WATER QUALITY MEMORANDUM

Utah Coal Regulatory Program

RE: Third Quarter 2015 Water Monitoring, Bowie, Fossil Rock Mine, C/015/0009, Task ID #5007

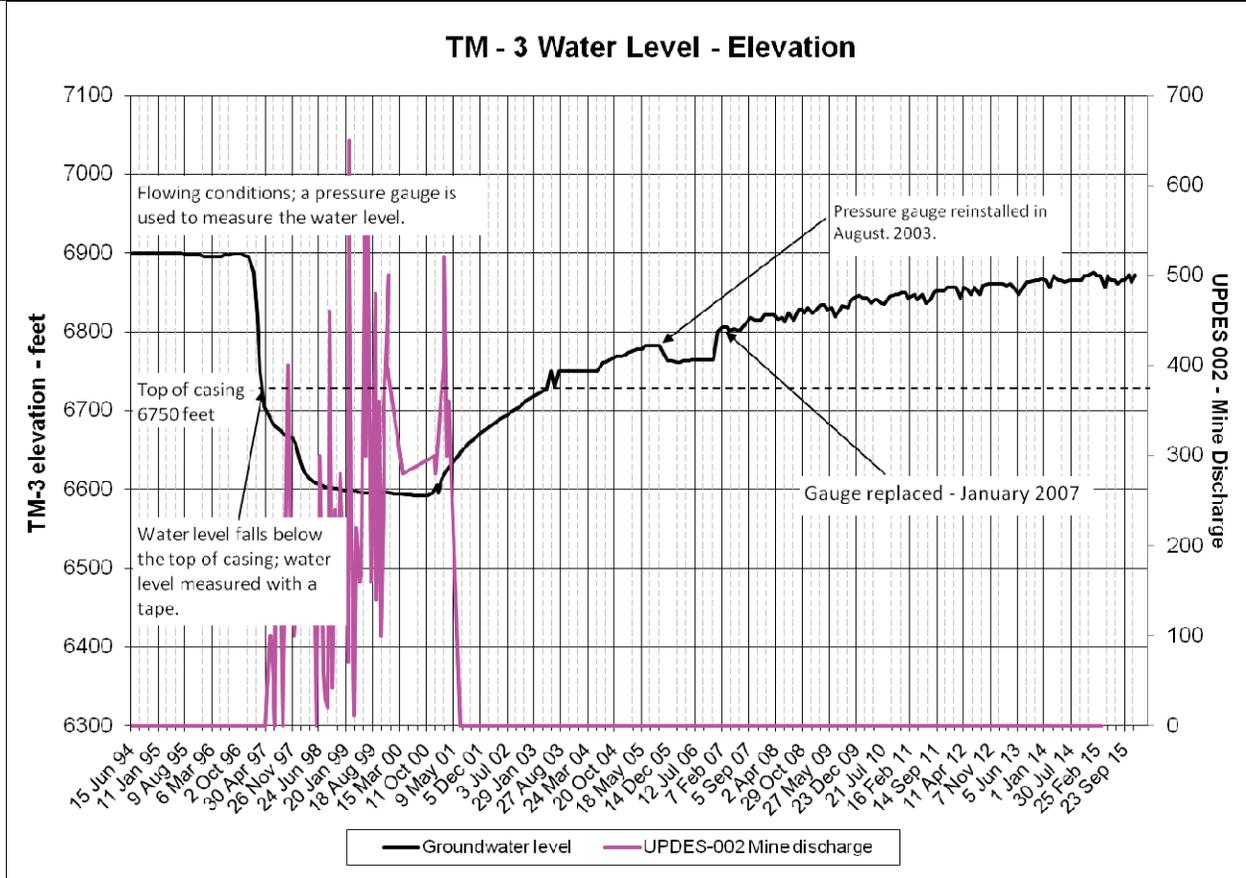
Figure 2. TM-3 water elevation peaked in June 2005, remained steady through October, dropped 18.5 ft in November and December 2005 and remained virtually unchanged during 2006. The pressure gauge was replaced in January 2007 and values jumped to approximately match the pre-2006 curve. During the first half of 2007 the curve was relatively flat, but it has been steadily climbing. The outgoing document Reduce Hydrologic Monitoring Sites, PacifiCorp, Deer Creek, C/015/0018, Task ID #4332 stipulates this well should not be released until 6,900 ft is reached.
